Title			ISC System Wiring Diagram		
Size	Number			Revision	
B	D1900511			V5	
Date:	2/25/2021	Sheet	1 of 38		
File:	C:\Users\...\ISC_C1_SH1.SchDoc	Drawn By:	Filiberto Clara

ISC System Wiring Diagram

ISC-R5 Rack

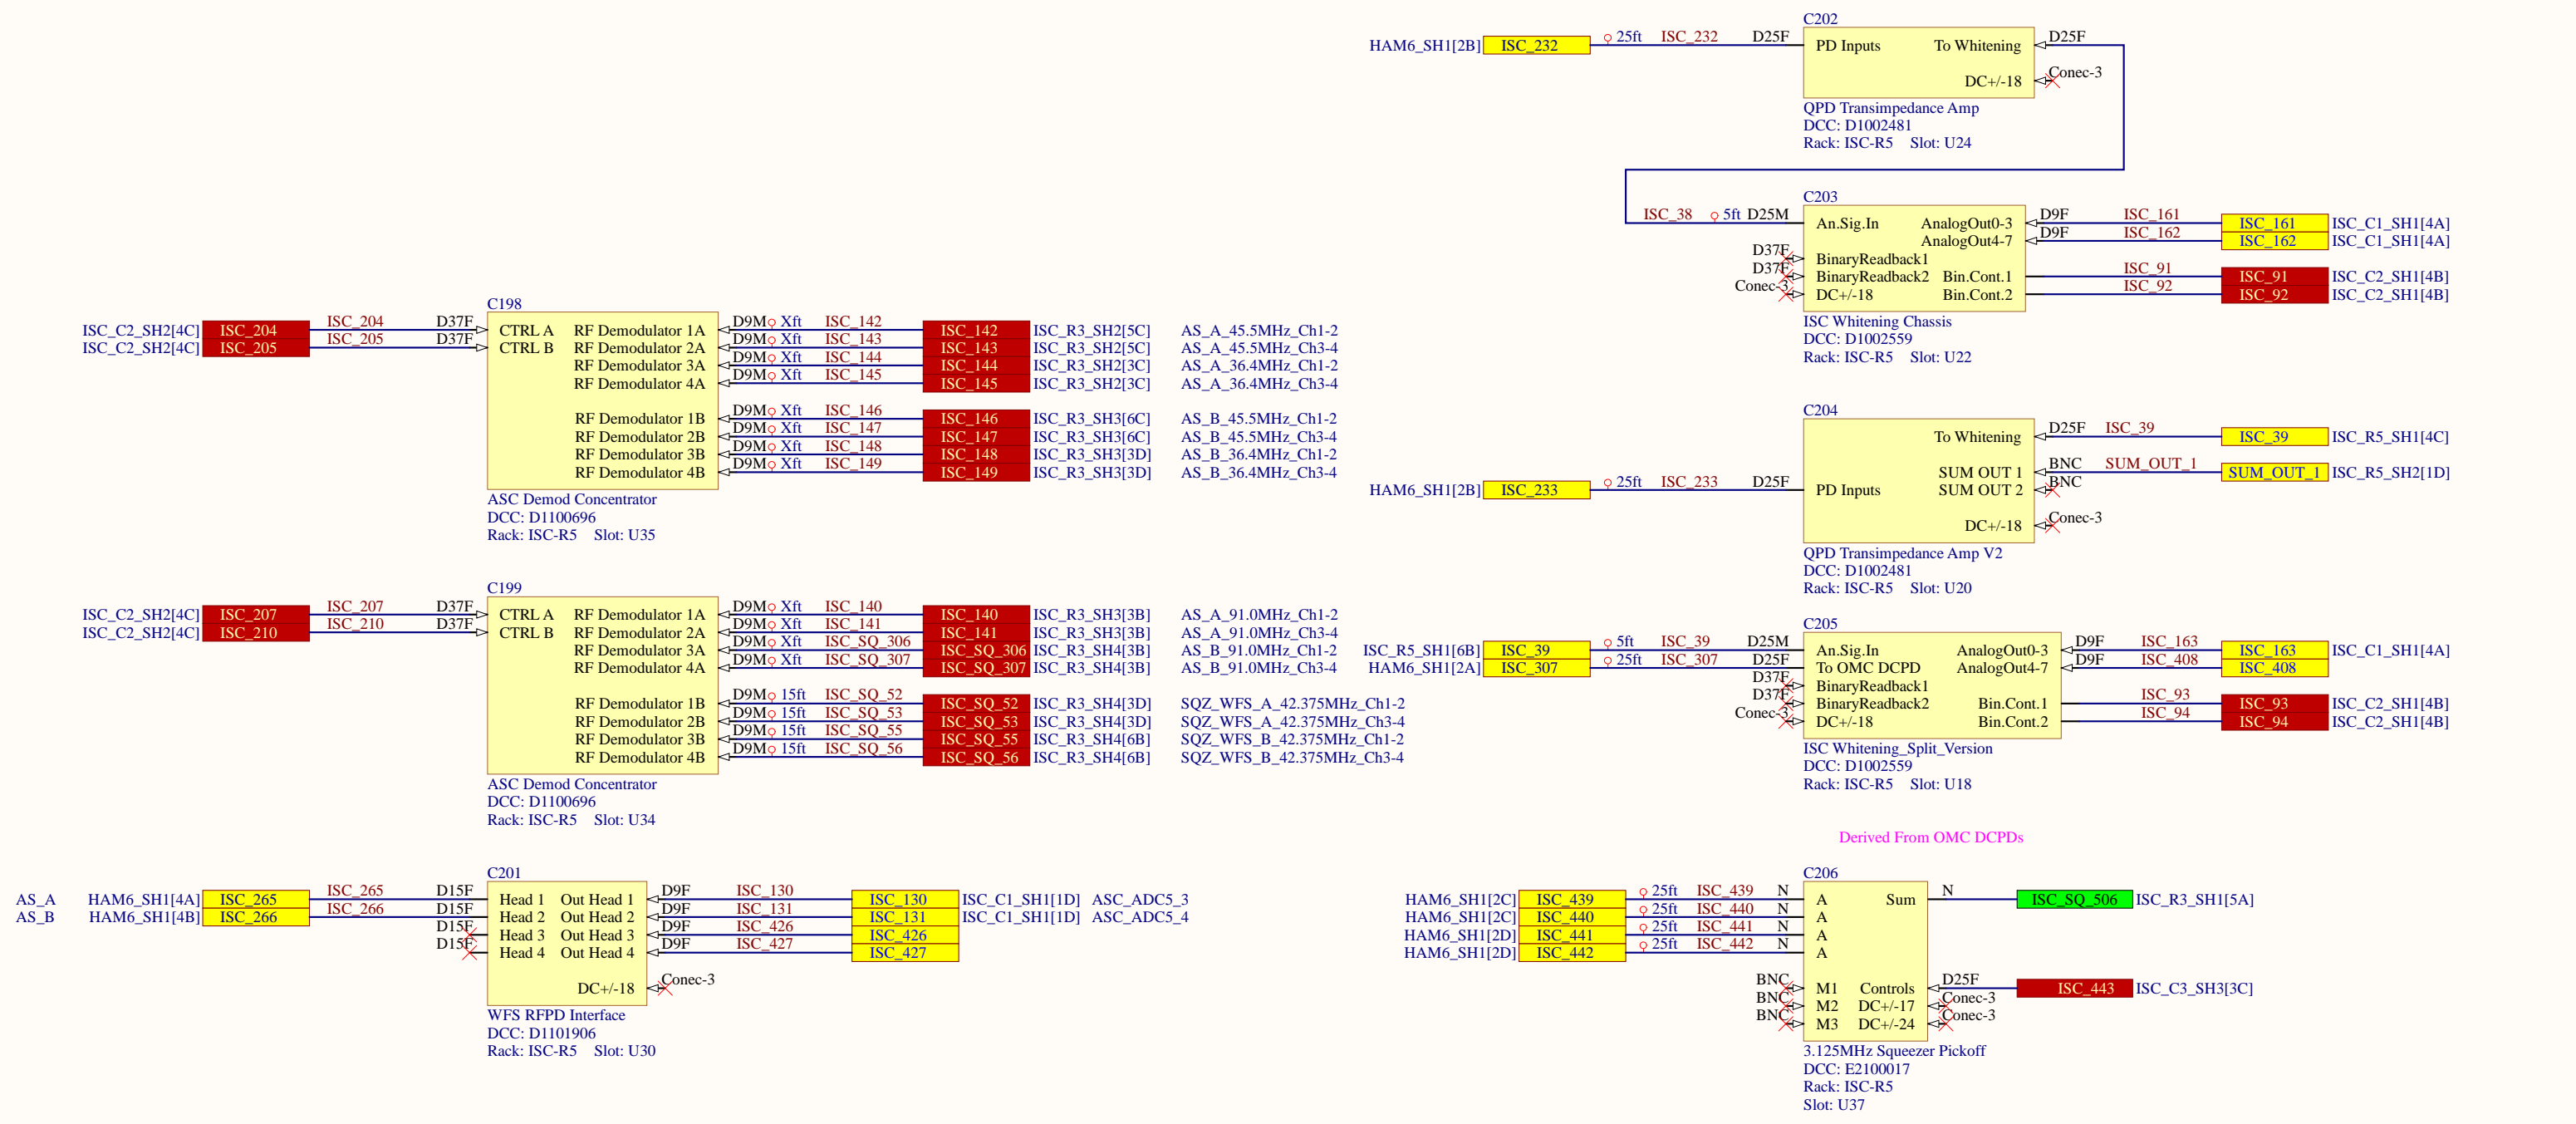
The whitening chassis and the OMC berakout will be replaced for the new in-vac DCPDs.
The 3.1MHz signal will be brought out separately on coax.

ISCT1 - Right Side

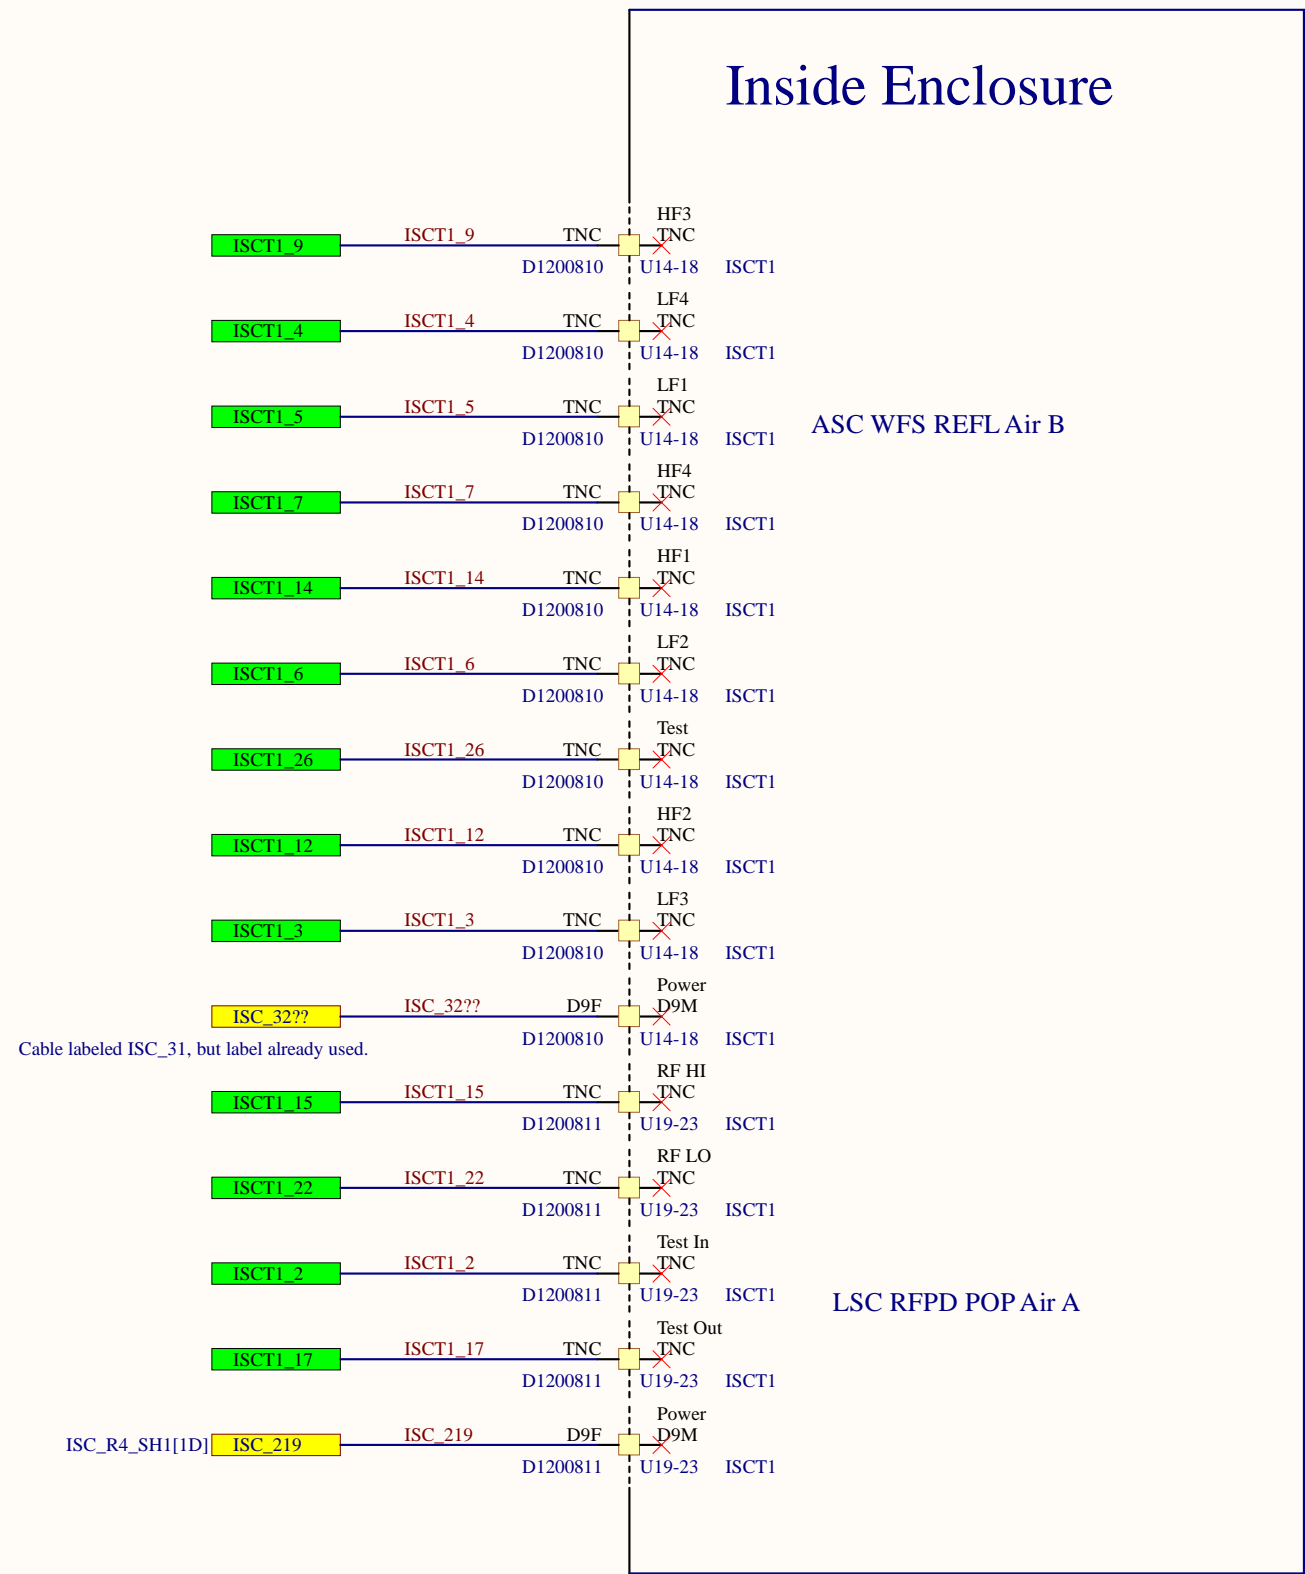
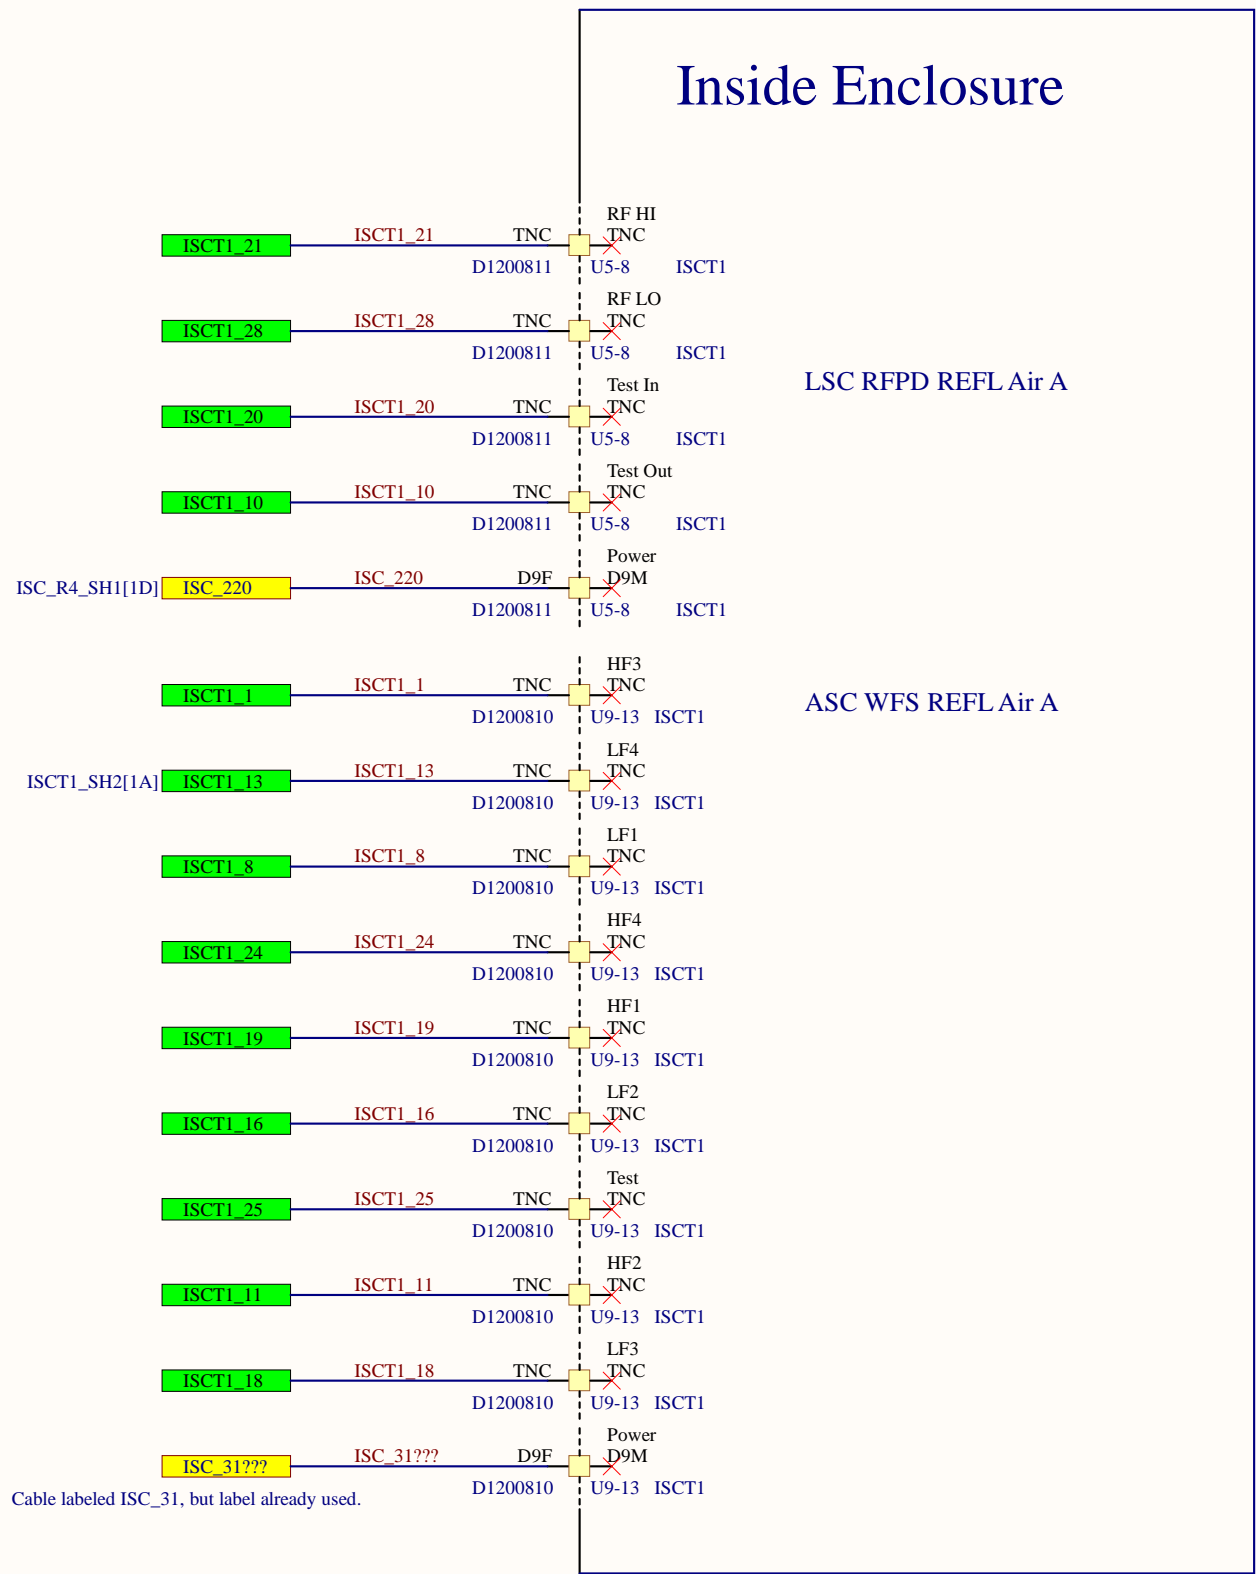
Cable labeled ISC_31, but label already used.

Cable labeled ISC_31, but label already used.

IOT2 - Left Side

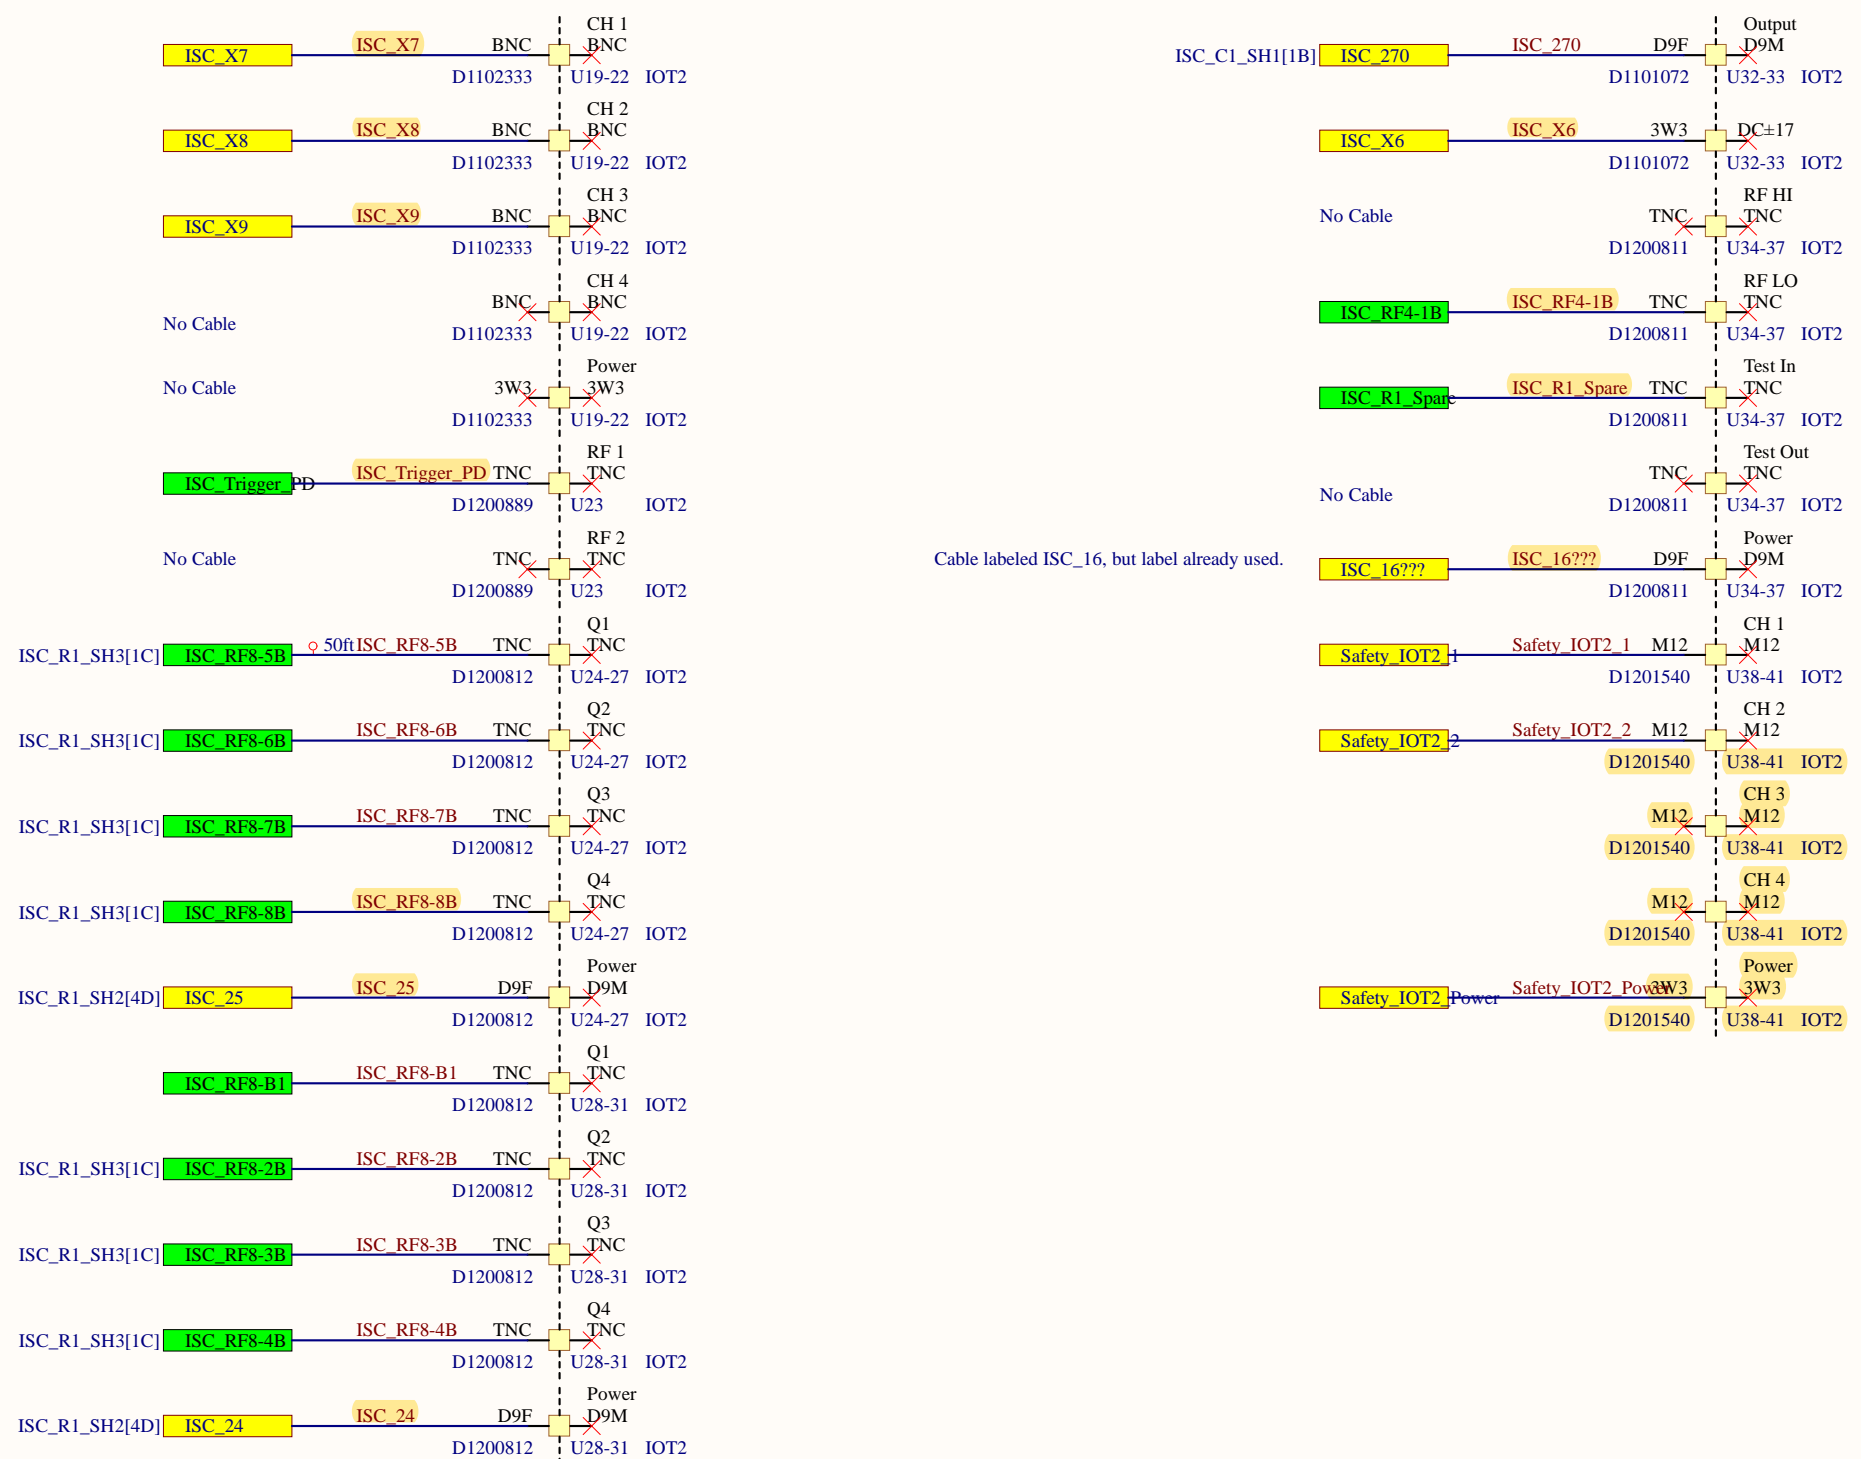
Cable labeled ISC_16, but label already used.

HAM5 DCPD Beam diverter?

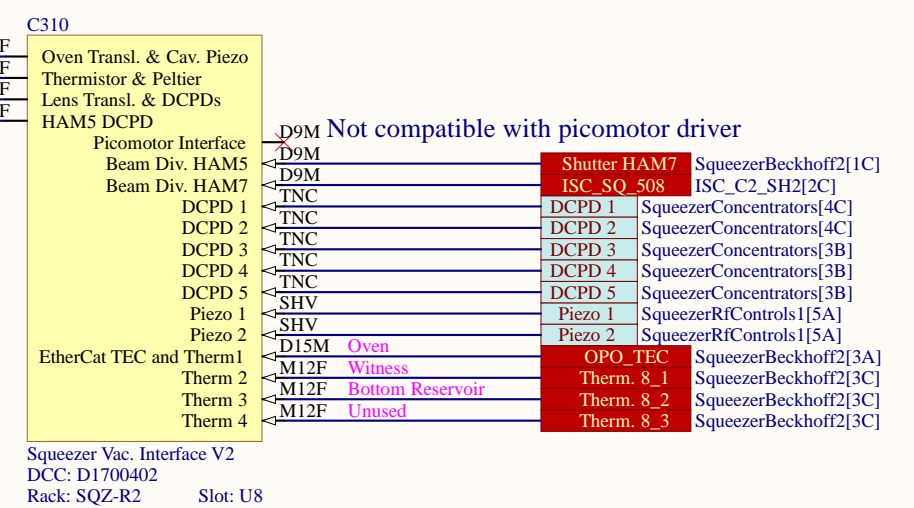
Not compatible with picomotor driver

Swap DCPD1 & DCPD2 for H1
